**MAUNA KEA SCIENCE RESERVE: COMPLEX
DEVELOPMENT PLAN
FINAL ENVIRONMENTAL IMPACT STATEMENT**
MAUNA KEA, HAMAKUA, HAWAII January 1983

This Final Environmental Impact Statement consists of Volume 1 of the draft EIS, as revised; comments received during the public review period of the draft EIS; and, responses to reviewers comments. Volume 2 of the draft EIS, Technical Appendices, is hereby incorporated by reference, in its entirety, into this Final EIS.

The Final EIS for the Mauna Kea Science Reserve CDP, which was filed with the Environmental Quality Commission (EQC) on 4 January 1983, contains revisions and additions to Volume 1 of the draft EIS. Volume 2, Technical Appendices, was not reprinted but was incorporated into the Final EIS by reference. The revised pages, together with the letters received during the review period and our responses, are attached for your information. (Note: Material in parentheses () has been deleted, underlined material has been added). The following changes were incorporated into the Final EIS:

FIGURE NO. 11

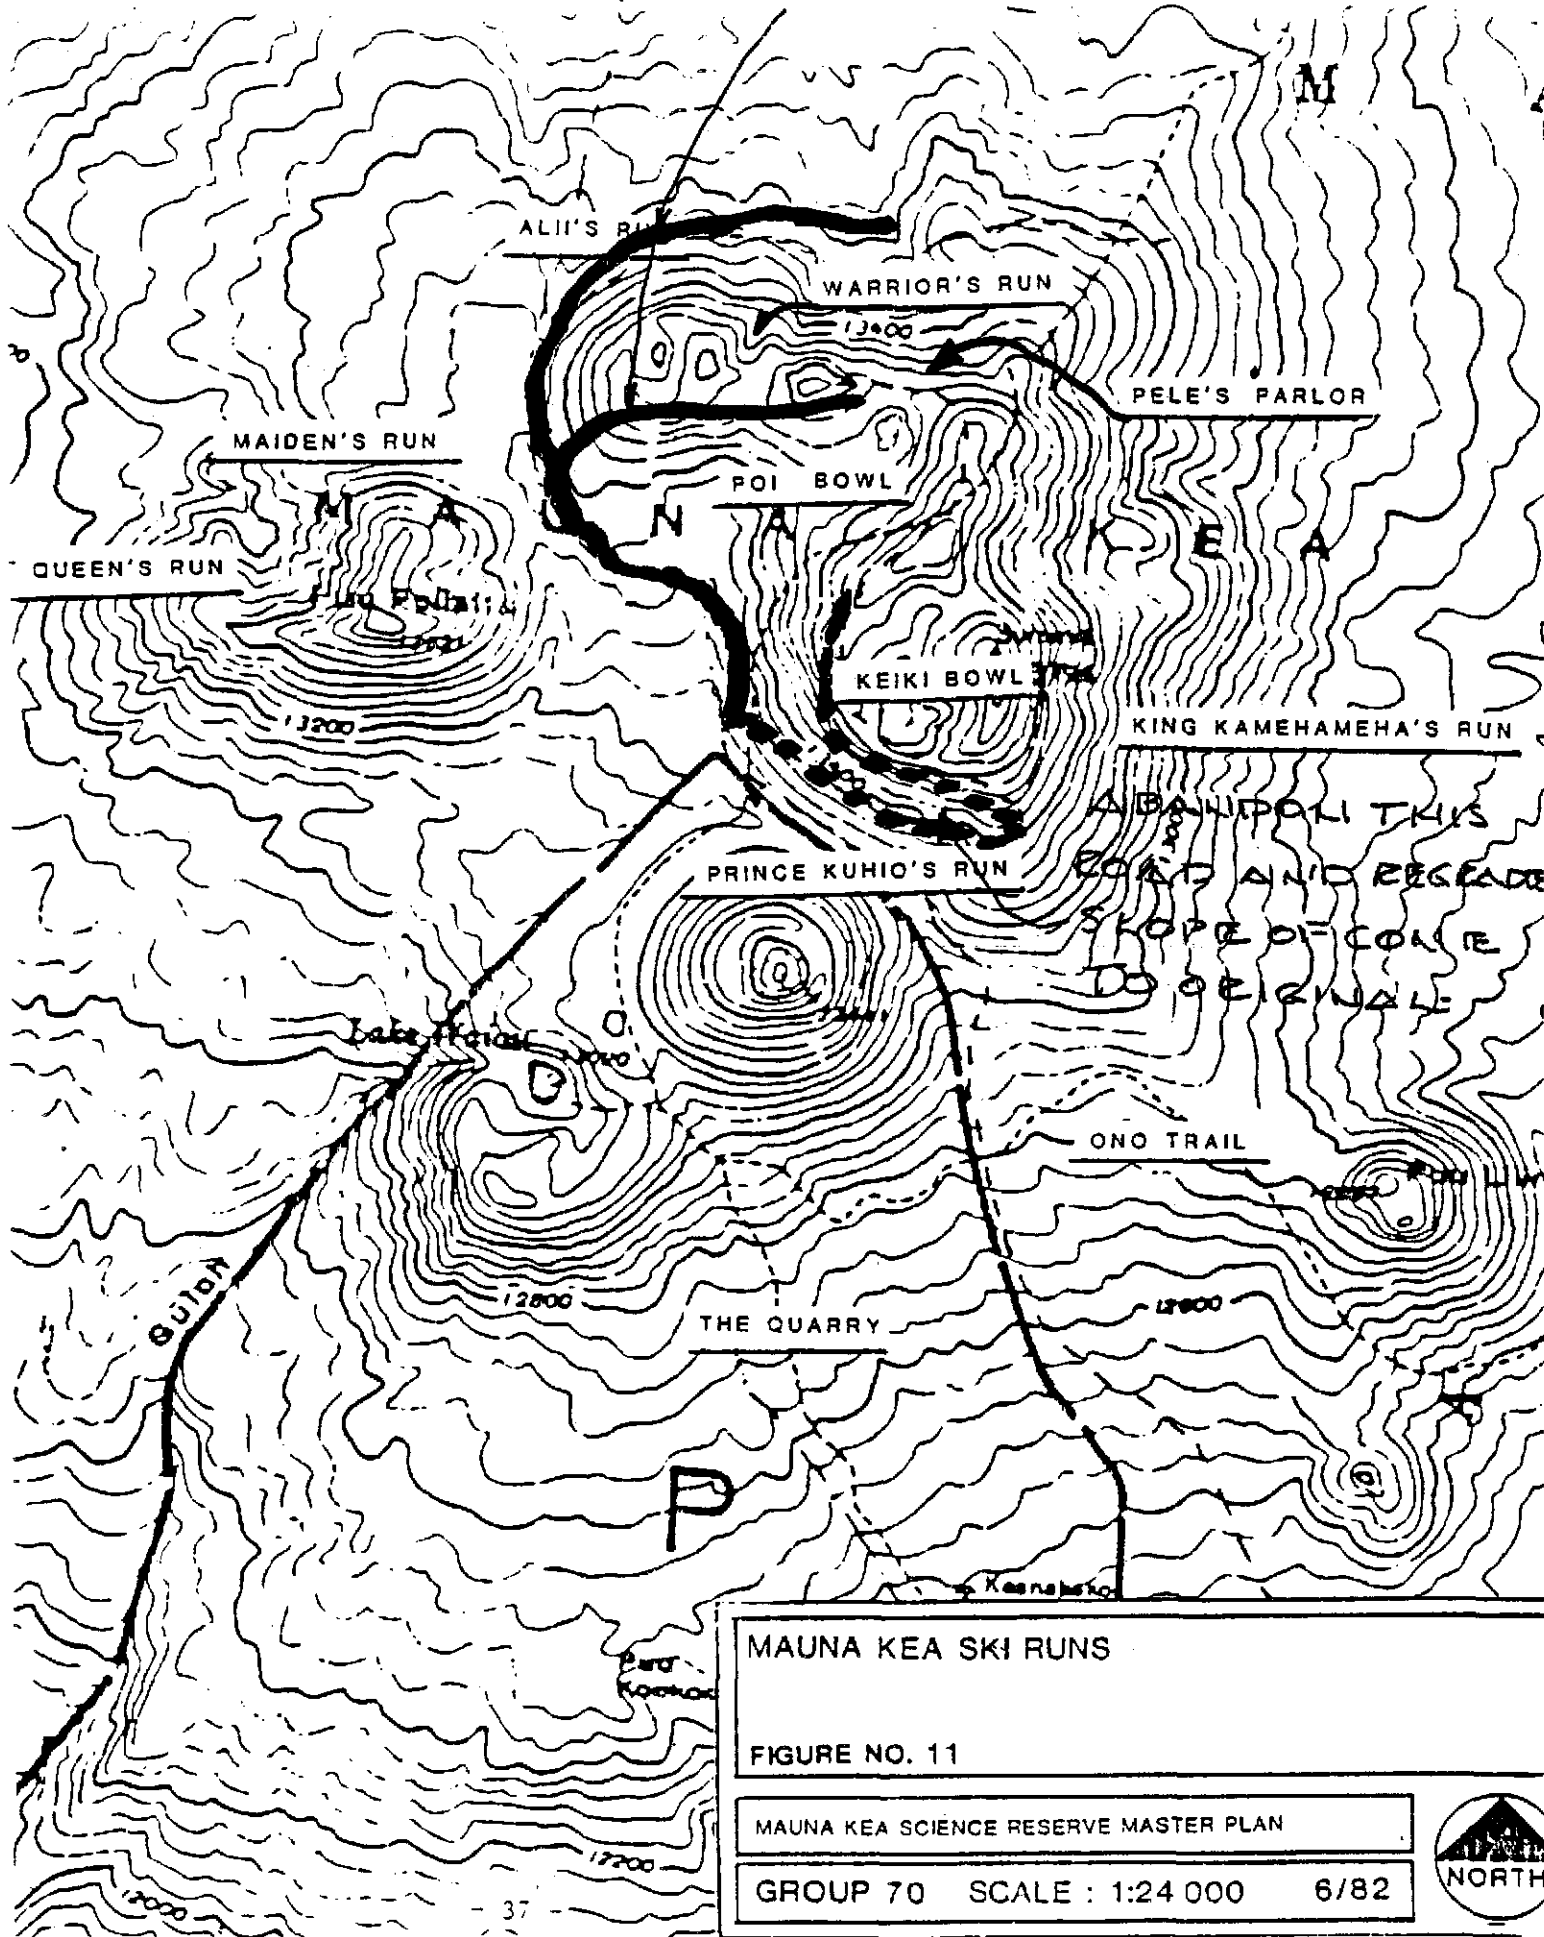
2. Paragraph B 2.0 Access Roads - Fig. 2 and Fig. 11
To increase the recreational use of the summit for winter sports, we wish to propose including in the master plan at this time the early installation of a new access road that would open up the bottom of Alii, Warrior and Pele's Parlor ski runs. This road would improve and extend the existing road from the proposed Cal Tech telescope, past the NRAO site and around the north and northeast base of the summit cones containing the proposed U.C. and IRTE telescopes. This road would provide access to the most dependable ski runs on Mauna Kea from the standpoint of adequate and long lasting snow. The proposed alignment is shown on the attached marked up copy of Fig. 11. This road will eventually also serve telescopes to be built on the summit shoulder to the northeast as shown on Fig. 3 of the EIS.
